NHT Fashions Ltd.

Plot# 20-22, Sector#05, CEPZ, Chittagong.

Survey Date: 8th March 2015

Elevation on grid 1 shows bracing grid G'-G (Zamil Steel Construction Drawing E25 Rev 1)

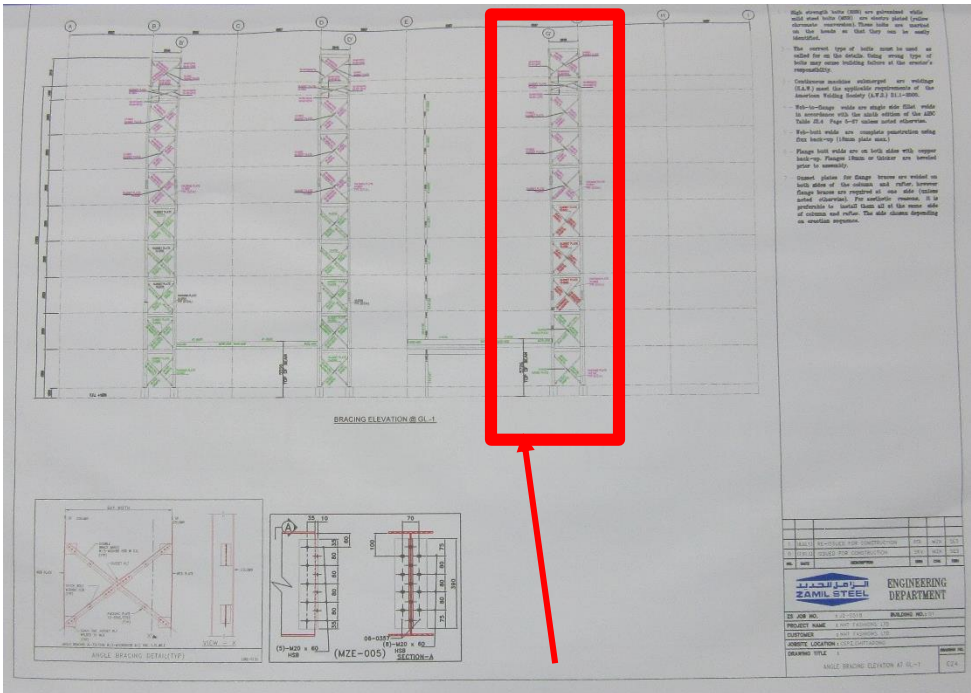
Missing bay of bracing

- Construction drawings show a bay of bracing at grid 1/G'-G. This did not appear to be present in the completed building.
- The braced bays and RC walls on their own may not be sufficient to stabilize a building of this size. Therefore we assume that stability is also provided by moment frame action of the beams and columns. The stability system of the building should be reviewed by the Building Engineer.

Roof Slab (8th Floor)

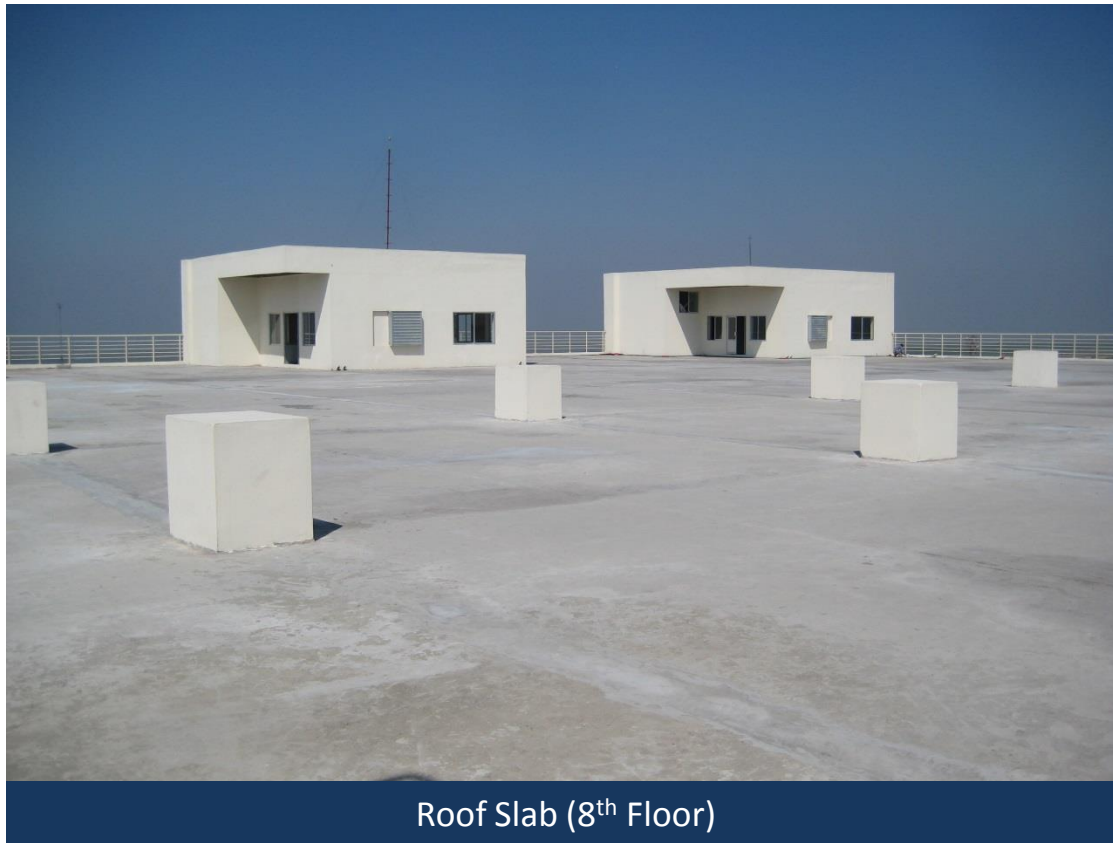
- There did not appear to be any waterproofing to the concrete roof at 8th floor.
- The concrete of the roof will be subject to large temperature changes as it heats up in the sun and cools. This will induce stresses in the structure and could lead to cracking of the concrete slab.
- In the long term the cracking and lack of waterproofing could cause leaks and durability issues for the structure.
